Addendum No. 3

Date:	April 8, 2013
To:	Contractors
From:	Matthias Mueller – Program Director
Reference:	Bachelor Enlisted Quarters Facility Utah National Guard – Camp Williams, Utah DFCM Project No. 10281480
Subject:	**Addendum No. 3**

ADDENDUM THREE

BACHELORS ENLISTED QUARTERS FACILITY

E2 PARKING LOT LIGHT POLE BASE DETAIL (ZL-11)

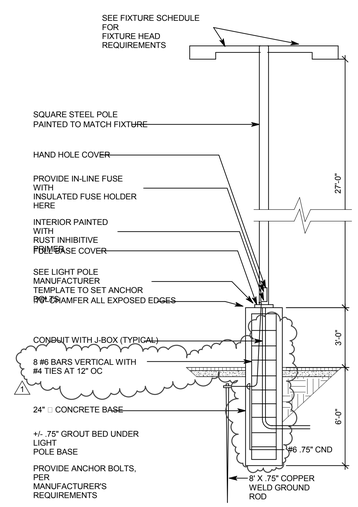
3.E02 Sheet ES501 – Modified the light pole base detail to have ties at 12-inches on center for the entirety of the pole base. See the attached sheet ES501.

C6 LEVEL 1 COMMUNICATIONS AND AUXILIARY PLAN - NORTH WING

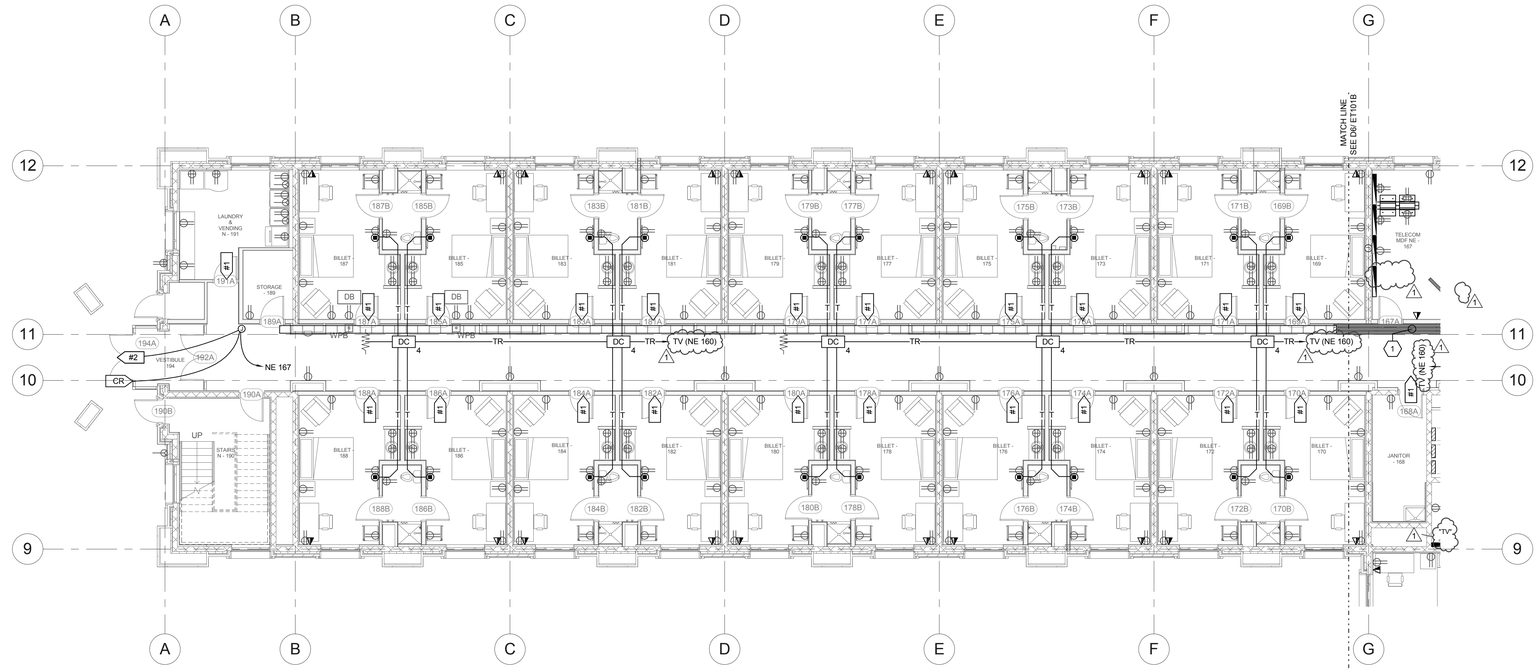
3.E05 Sheet ET101A – Detail C6. Changed destination notes for TV cable from NE 167 to NE 160. See the attached sheet ET101A.

3.E06 Sheet ET101A. Added General sheet Note #2 that reads: "All Visipatch panels and other termination equipment shall be in compliance with the most current G6 standard and shall be approved by UTNG prior to ordering equipment." See the attached sheet ET101A.

D6 LEVEL 1 COMMUNICATIONS AND AUXILIARY PLAN - EAST WING

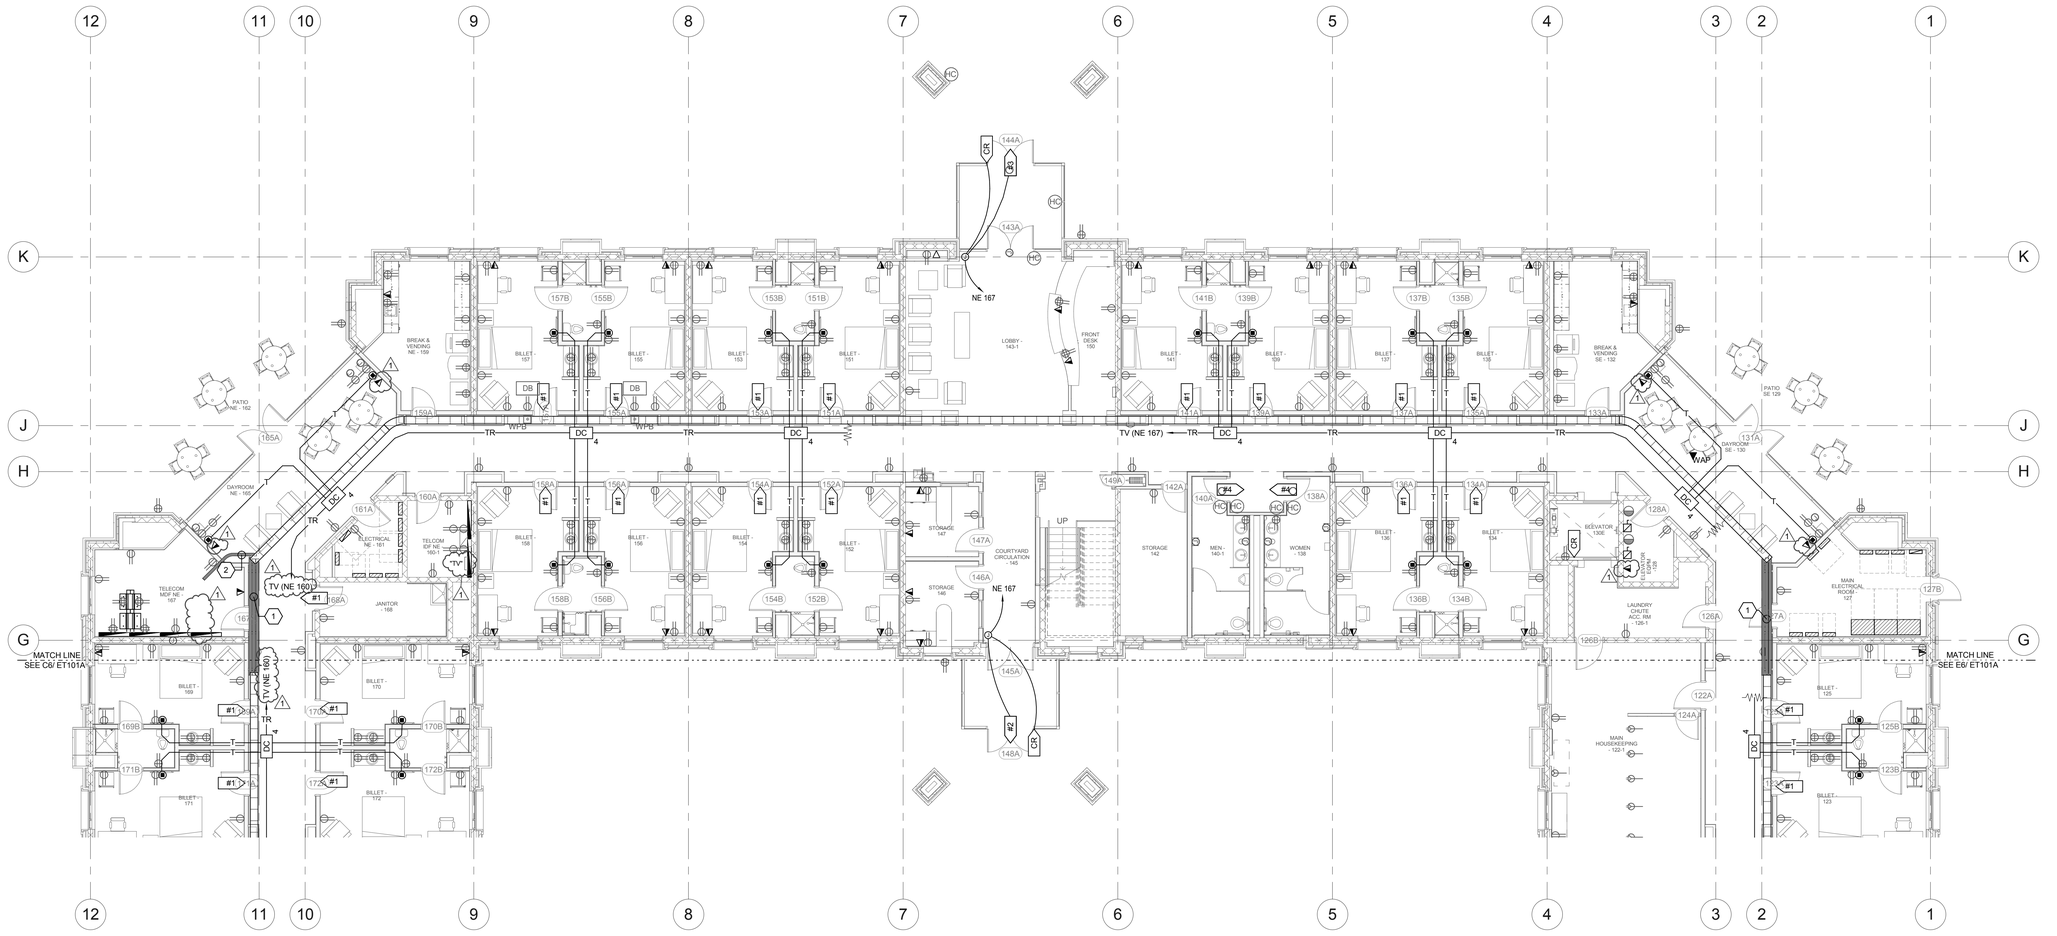
3.E07 Sheet ET101B, Detail D6 - Changed destination notes for TV cable from NE 167 to NE 160. See the attached sheet ET101B.

3.E08 Sheet ET101B, Detail D6 - Deleted TV termination location from NE 167 and added the location to NE 160. See the attached sheet ET101B.

3.E09 Sheet ET101B, Detail D6 - Changed the data symbols in various locations to match the standard data symbol for clarity. See the attached sheet ET101B.

3.E10 Sheet ET101B. Added General sheet Note #2 that reads: "All Visipatch panels and other termination equipment shall be in compliance with the most current G6 standard and shall be approved by UTNG prior to ordering equipment." See the attached sheet ET101B.

E6 TELECOMMUNICATIONS CONDUIT RISER DIAGRAM
SCALE: NTS

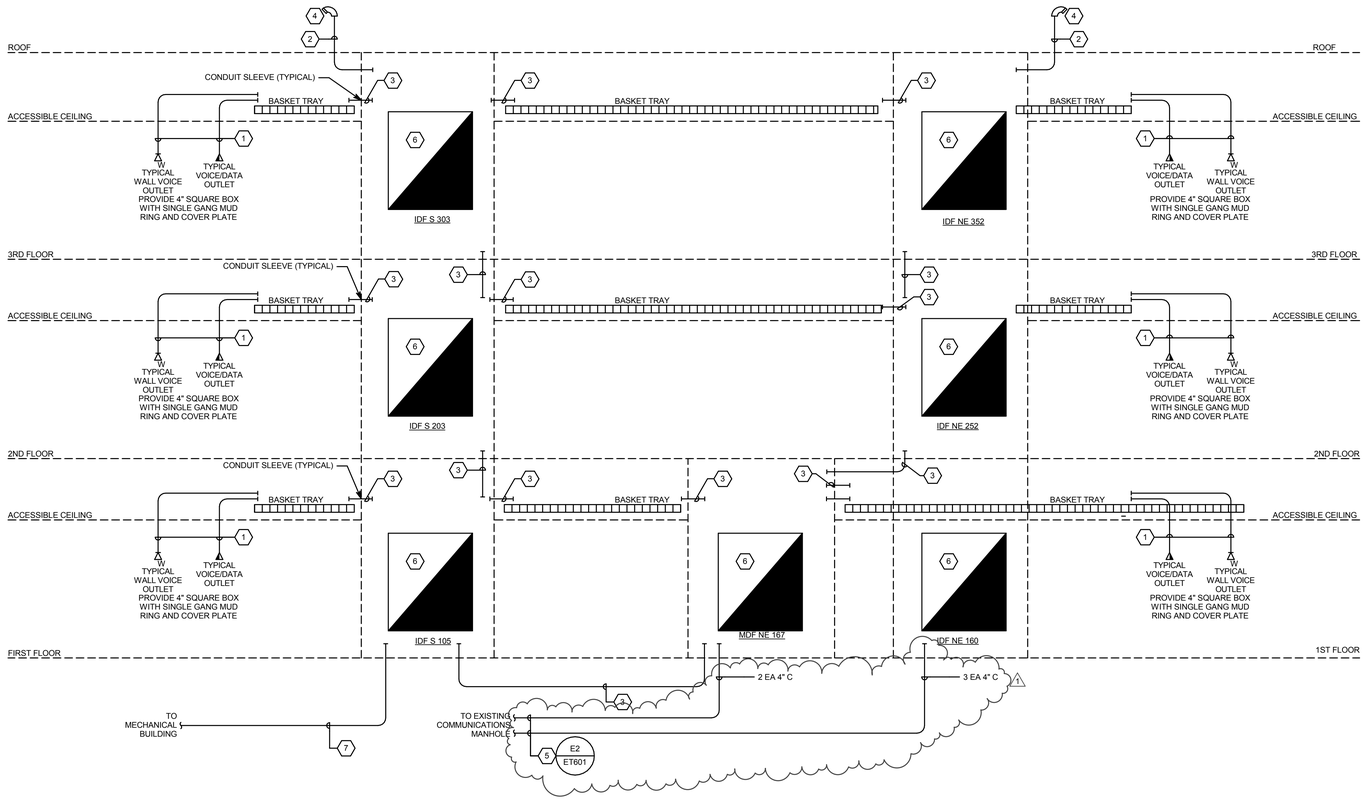
3.E13 Sheet ET601, Detail E2- Changed the 2-inch conduit for CATV to a 4-inch conduit. This detail also now indicates that 2 of the 5 each 4 inch conduits will terminate in MDF Room NE 167 and the other 3 each 4 inch conduits will terminate in IDF NE 160. Four innerducts shall also be added to one of the three conduits to IDF NE 160. See the attached sheet ET601.

3.E14 Sheet ET601, Revised the conduit riser diagram. Three each 4-inch conduits for CATV and WIFI shall terminate in IDF NE 160 and 2 each 4 inch conduits shall terminate in MDF NE 167. See the attached sheet ET601.

E4 TV DISTRIBUTION SYSTEM SINGLE LINE DIAGRAM
SCALE: NTS

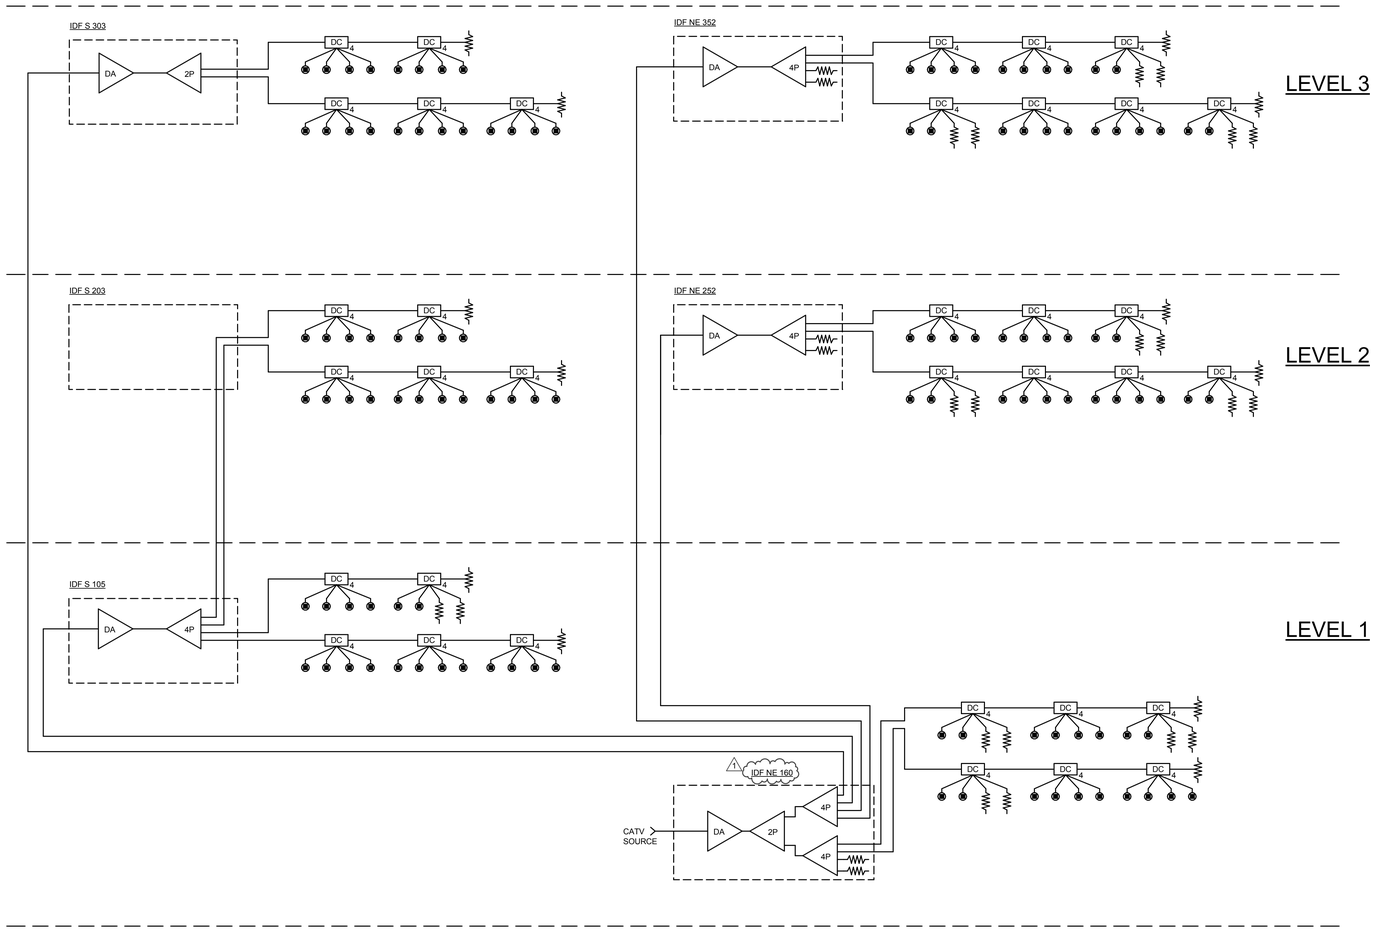
3.E15 Sheet ET602 - Detail D4. Changed label for the location of the TV headend equipment from NE 167 to NE 160. See the attached sheet ET602.

E6 TELECOMMUNICATIONS CABLING RISER DIAGRAM

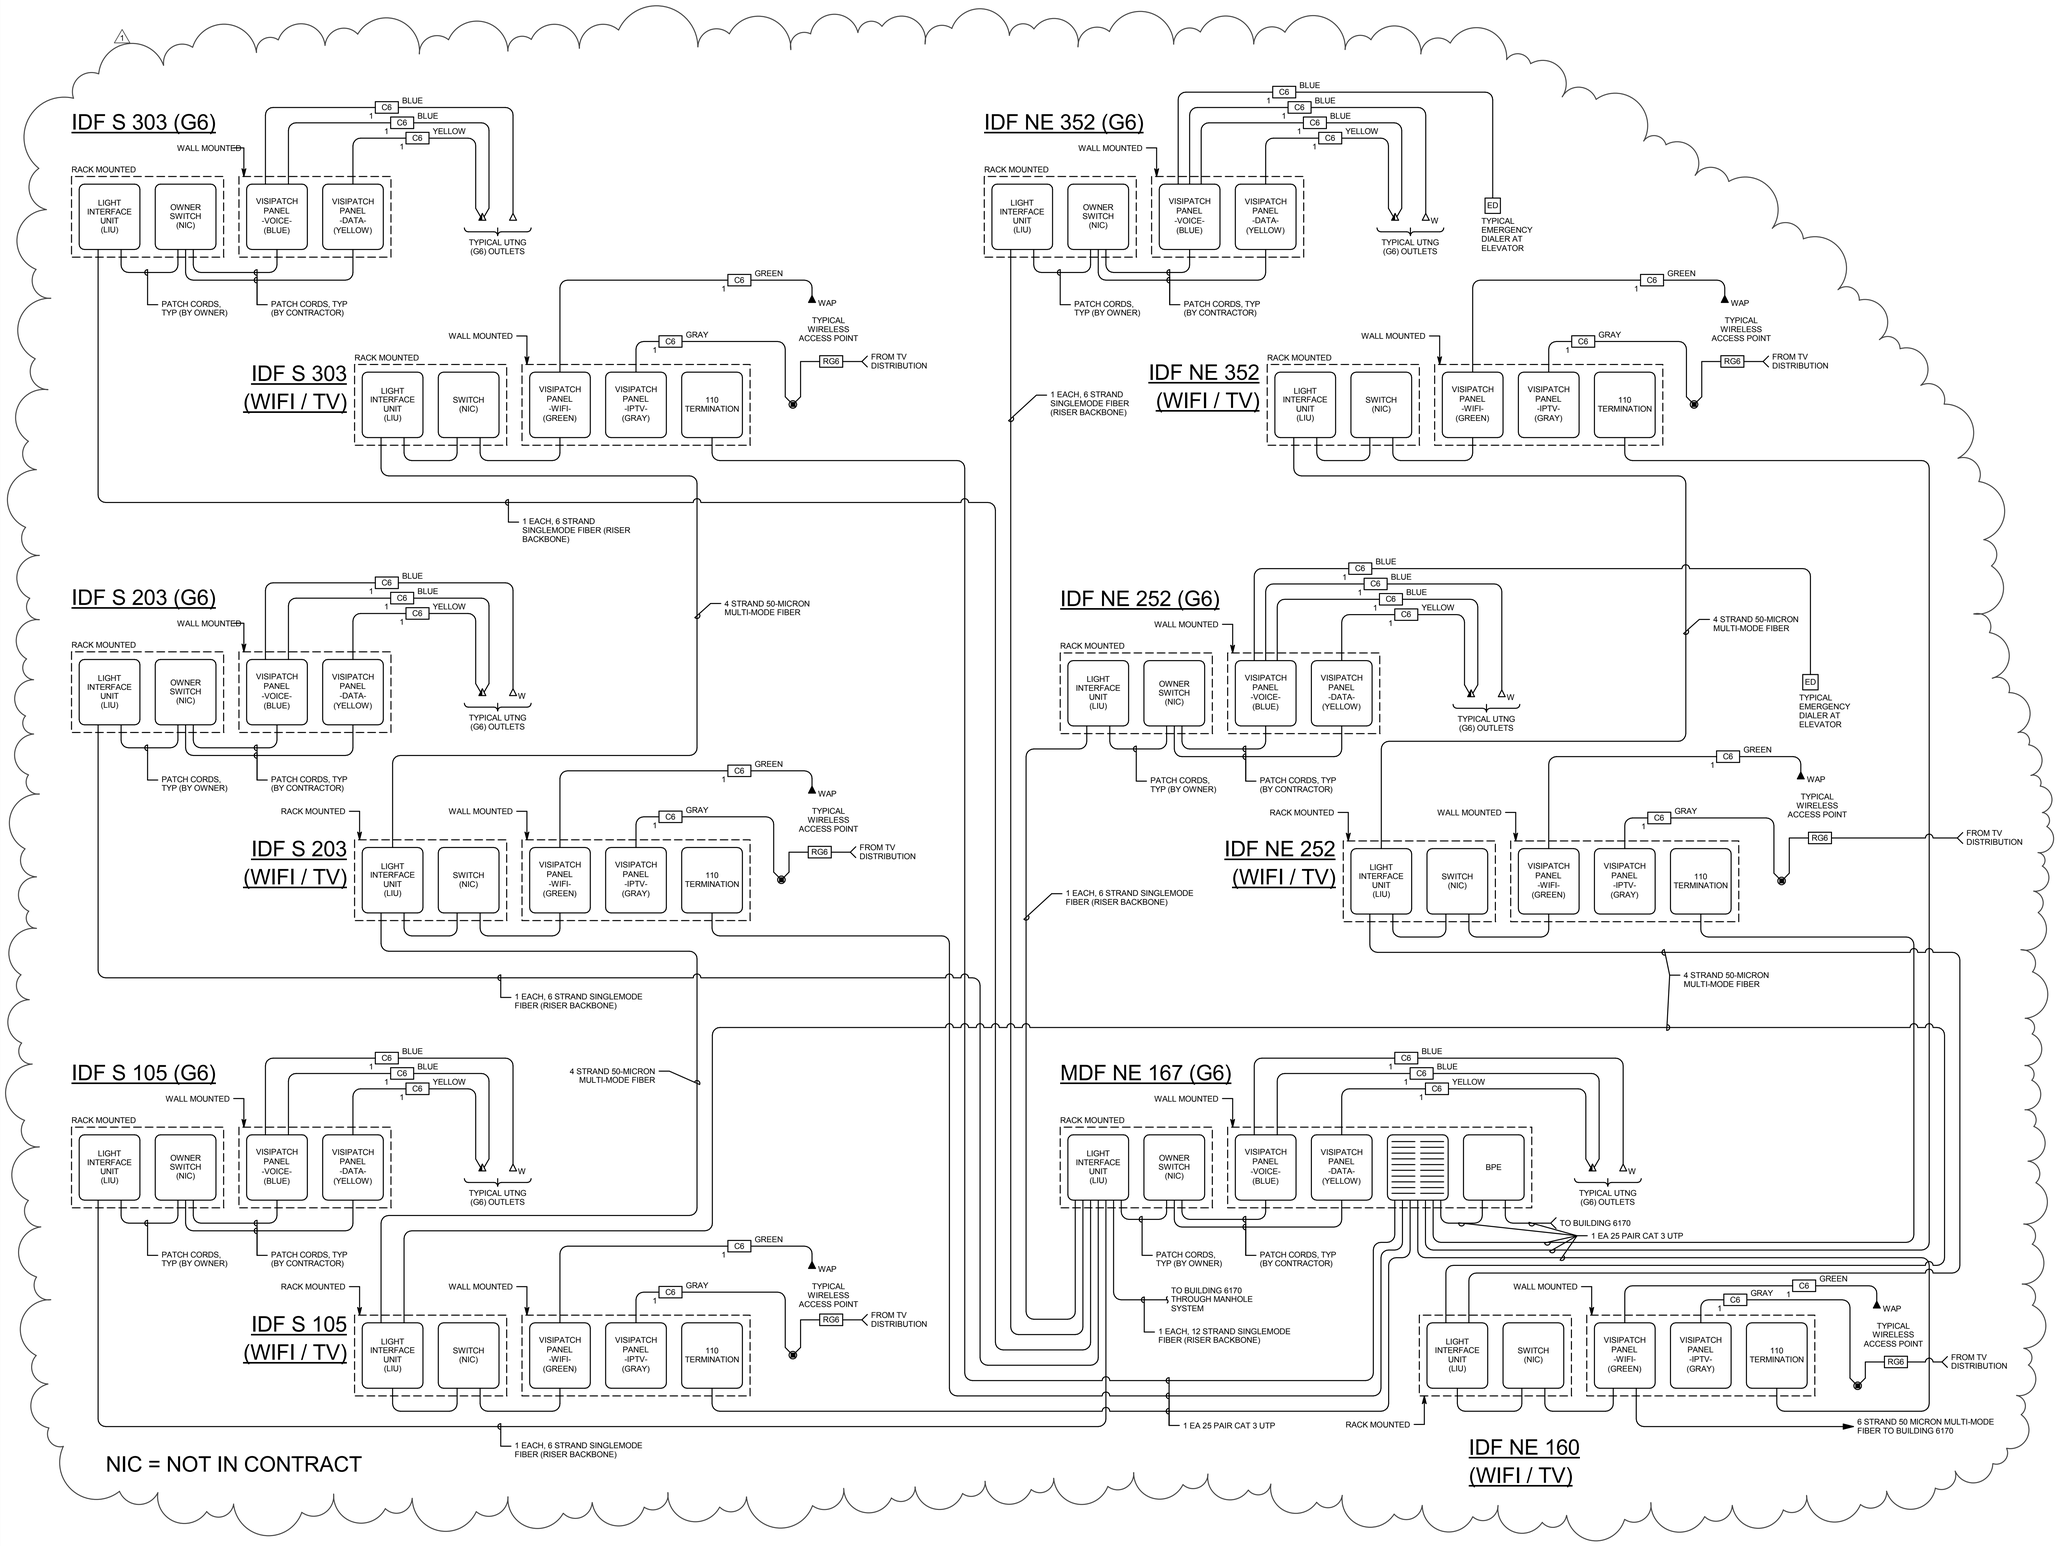
3.E16 Sheet ET603, Detail E6 - Added IDF NE 160 for the headend equipment for the WIFI data and the TV distribution systems. See the attached sheet ET603.

3.E17 Sheet ET603, Detail E6 - Revised the detail to indicate the TV visipatch panel being separated from the LAN G6 data equipment and installed with the WIFI data visipatch equipment. See the attached sheet ET603.

3.E18 Sheet ET603, Detail E6 - Changed the backbone fiber cable for the LAN G6 voice/data system from 50 micron multimode to singlemode fiber: same quantity of strands. See the attached sheet ET603.

3.E19 Sheet ET603, Detail E6 - Added two labels to the fiber backbone for the WIFI system that read “4 strands 50 micron multimode fiber “ similar to the other WIFI backbone cables already labeled. See the attached sheet ET603.

3.E20 Sheet ET603. Added General sheet Note #2 that reads: “All Visipatch panels and other termination equipment shall be in compliance with the most current G6 standard and shall be approved by UTNG prior to ordering equipment.” See the attached sheet ET603.
